**Appendix C.4**  
**Public Comments (P/PH)**  
**P650-P751**

Comments on the Los Angeles Aerial Rapid Transit Project Draft EIR

Figure 3: Area of Potential Impact (API). Base image courtesy of Google Maps.

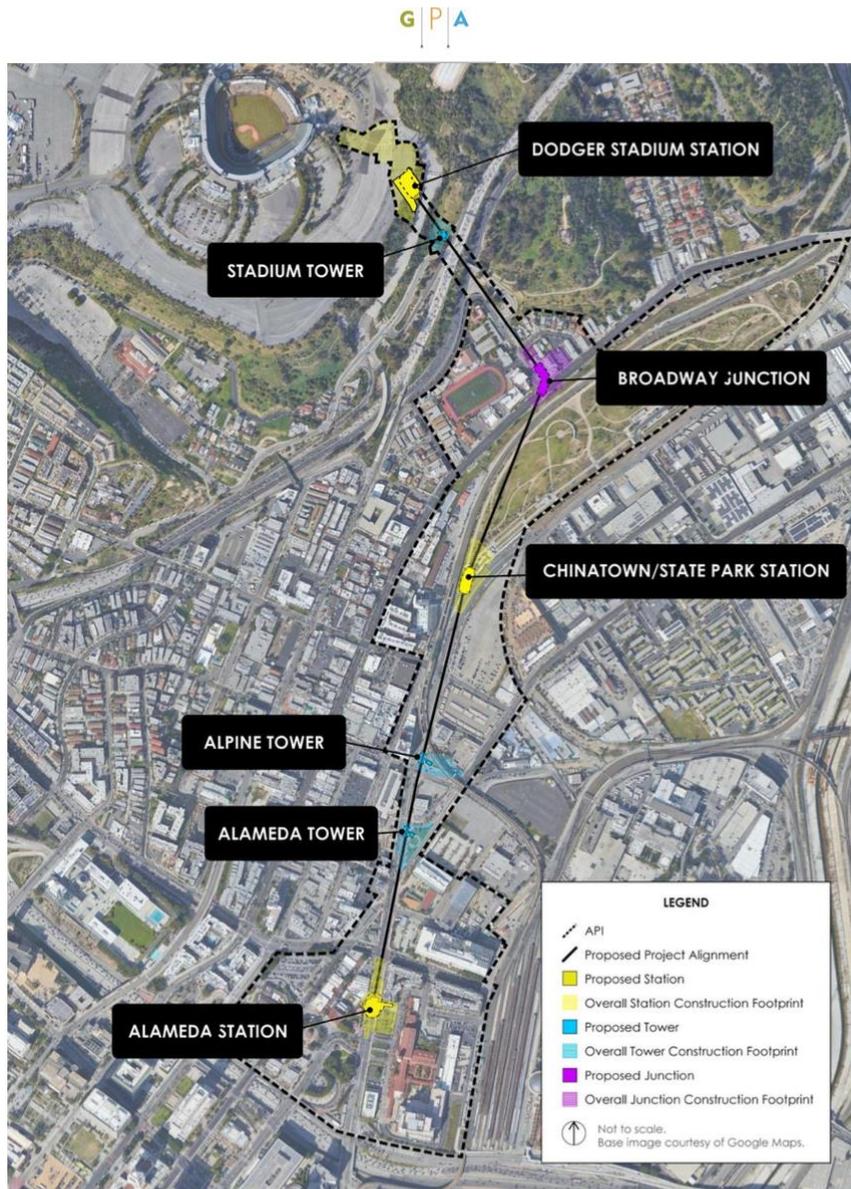
According to the DEIR, the alignment travels over City of Los Angeles right of way, City-owned Property, Metro Property, Caltrans Property, California State Parks Property, and Private Property, as shown in the following Figure reproduced from DEIR Appendix Q. A map should also be provided and coded to show the location of both the public and private land within the full Area of Potential Impact (API) as shown in DEIR Figure 3.1.1. The Project thus involves the use of public land – and the presumed forced taking of private land, not discussed in the DEIR – by a private Project sponsor.<sup>1</sup> DEIR Appendix Q also indicates that the Project requires the acquisition of American National Standards Institute (ANSI) required aerial rights<sup>2</sup> over the following properties, something not disclosed in the Project Description in the body of the DEIR:

**Large Trees East of SR-110 Northbound Lanes, Inside the Onramp Loop**

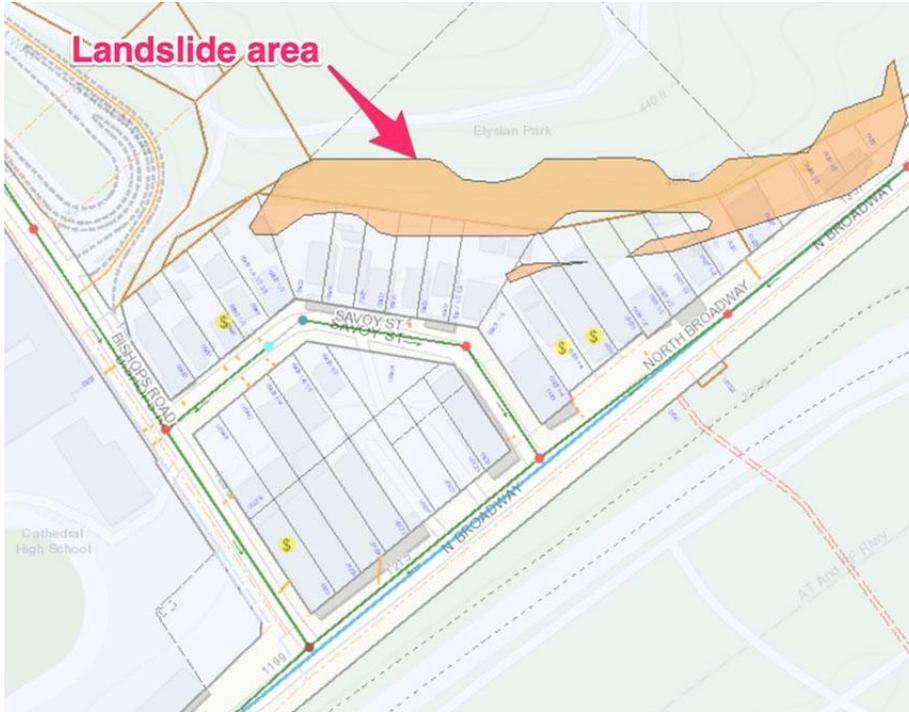
- Even with mitigation, the construction noise at NSR-17S is estimated at 80 to 90dB without mitigation and approximately 70-80dB with mitigation. This is outrageous.
- The vibration caused during construction of the Broadway Junction’s foundation may cause damage to our homes. There are also retaining walls in our 100+ year old hillside neighborhood that were built prior to current building codes that may be damaged and cause instability to our hillsides. Most of the properties on the west and north side of Savoy Street are in a landslide area. We are concerned that the Radio Hill hillside could become unstable during construction of the Junction and trigger a landslide.

## Construction Traffic and Staging for Maintenance/Repairs

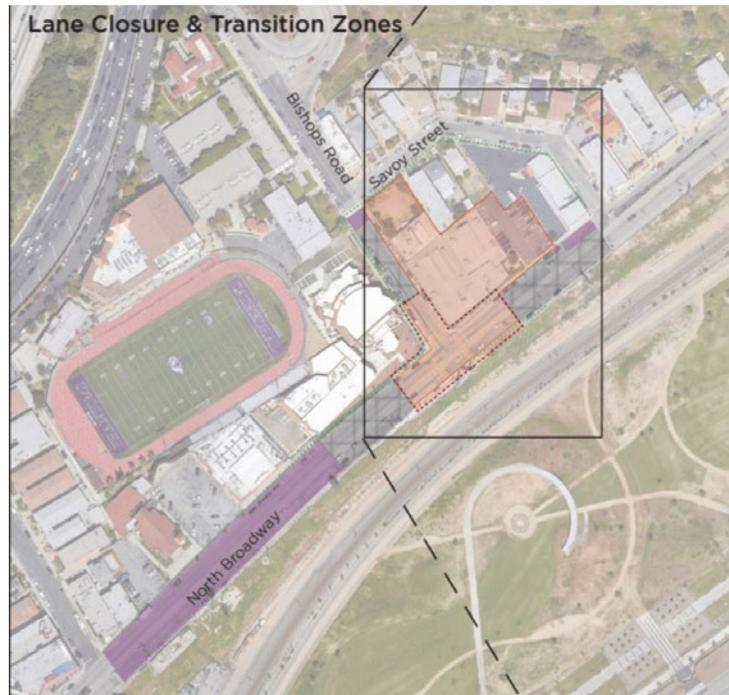
- During deck removal at the Broadway Junction, which is estimated at 3 weeks, will all of the traffic coming south on Broadway be funneled into our residential Street Savoy Street? This is a major thoroughfare for rush hour traffic into Downtown LA's Civic Center. If Broadway is closed and opened only to residents, how will visitors be able to drive into the area?
- The construction documents for the Broadway Junction do not show where the drive motor would be located. Is that at ground level?
- In the DEIR, it states, "Annual maintenance activities may require crane access at tower locations, including the potential to require the temporary closing of traffic lanes." Regular maintenance for this project will add to existing traffic congestion. Enhancing and expanding the Dodger Stadium Express service will not.

**Close Up of DEIR Image Showing the Base of the Alpine Tower**

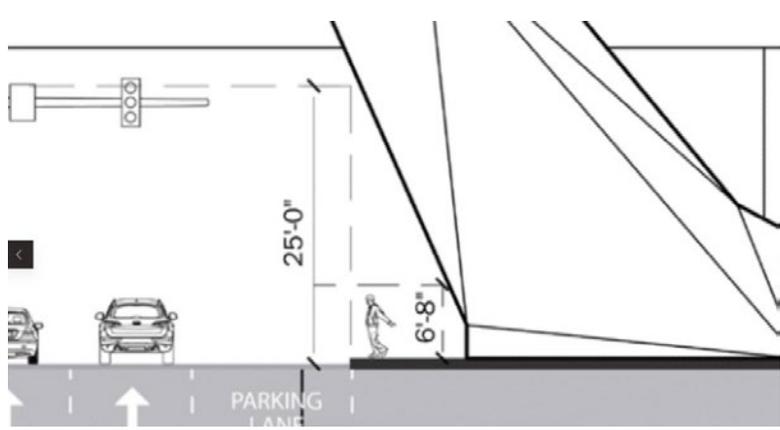
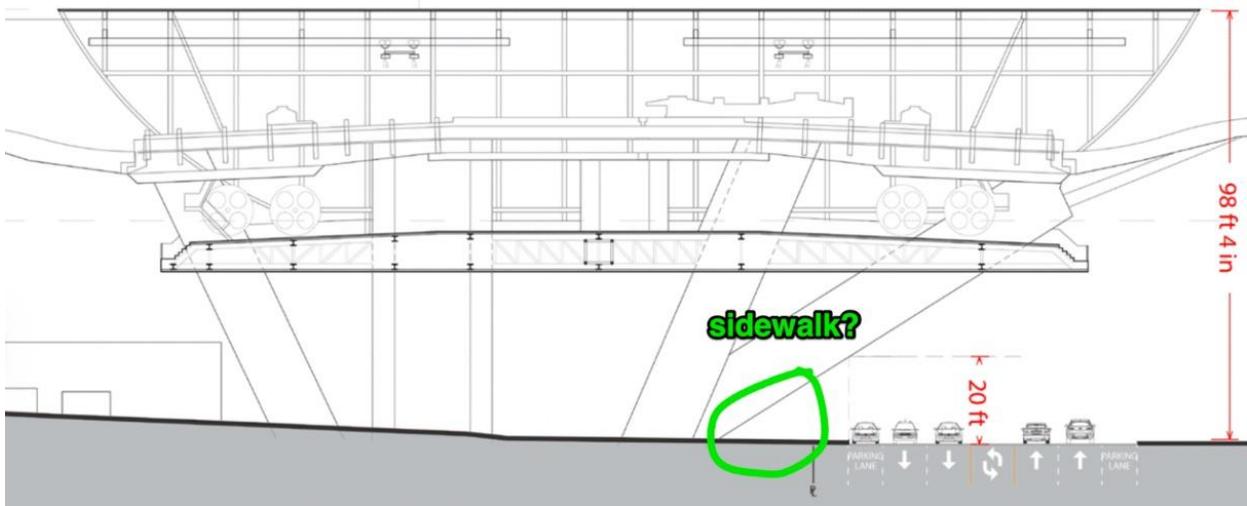
- Alpine Tower requires that a traffic lane on Alameda Street be sacrificed in order maintain a sidewalk around the base of the 200 ft tall gondola tower, which sits at the edge of the existing curb/sidewalk. The tower, however, still crowds the sidewalk by leaning into the airspace above the sidewalk. This looks like a very unpleasant pedestrian experience. The sidewalk needs to be wider, but this project is already taking space on our streets that could be used for wider sidewalks, bus lanes, and bike lanes. What is the impact of this tower, the space it needs on the street, to planned improvements to Alameda Street? Does this mean a protected bicycle lane or a bus lane can never be on this side of Alameda Street?

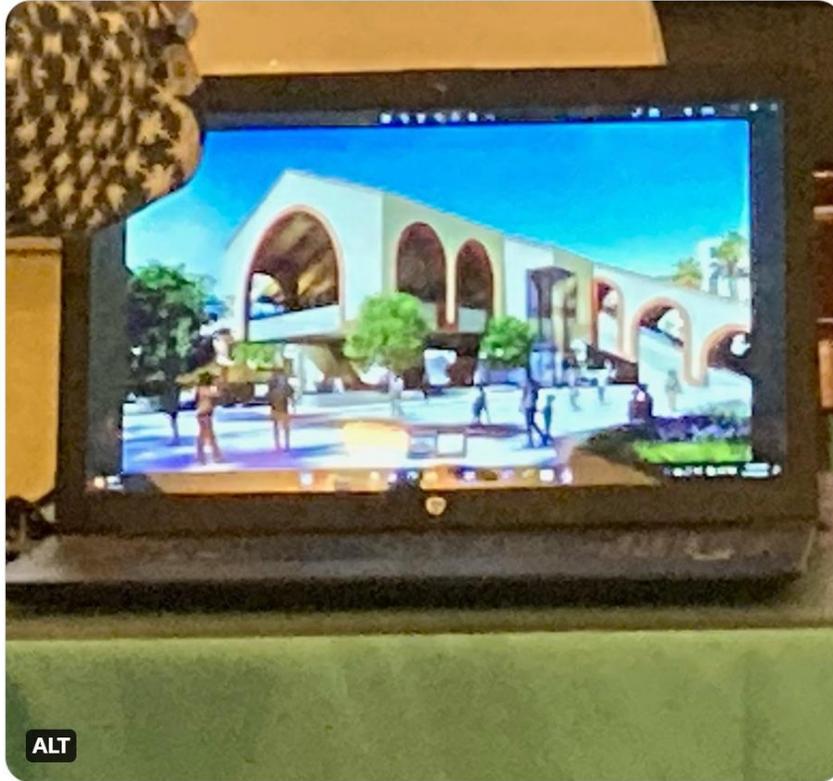
Gondola station and designs should not be cookie cutter or generic. This would be built at the birthplace of our city. LA ART claims this will be iconic, but how is the design iconic? There is no sense of place. Stations look generic and towers are a stark gray concrete. We don't need more gray concrete in our historic neighborhoods. The cabins also appear to be standard cabins.

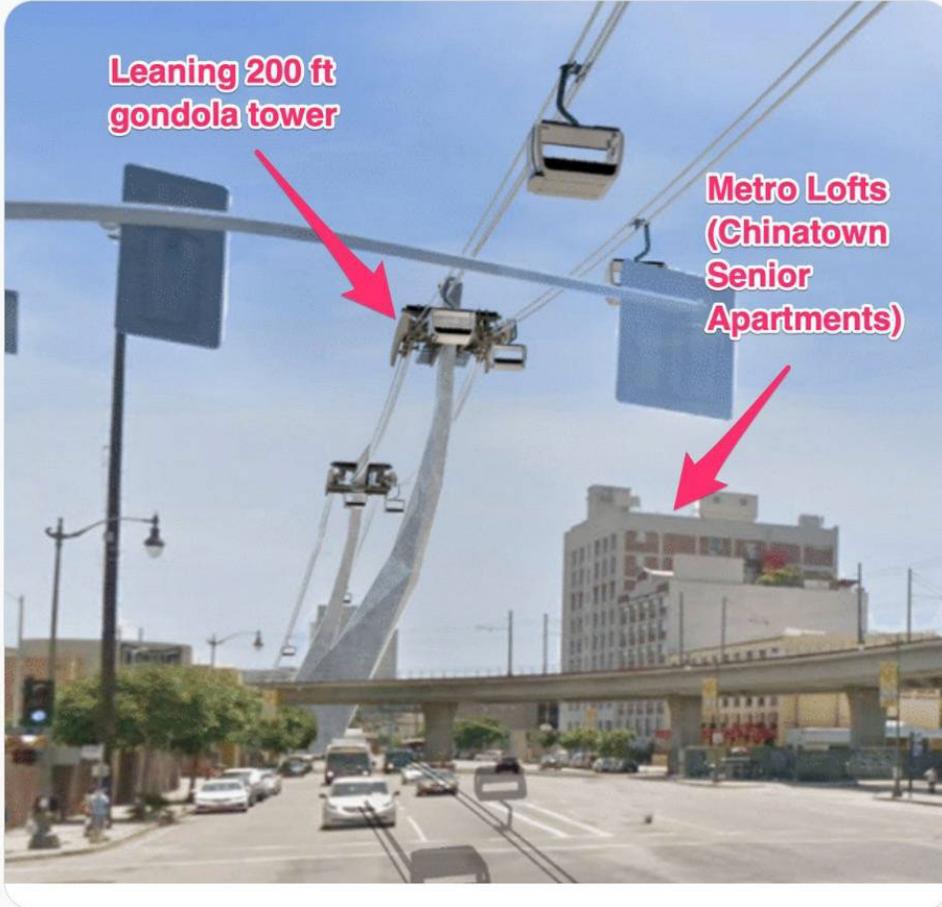
The "improved" station design that was recently presented to a group of El Pueblo merchants looks awkward, and like a dingbat, which is more of a mid century style.
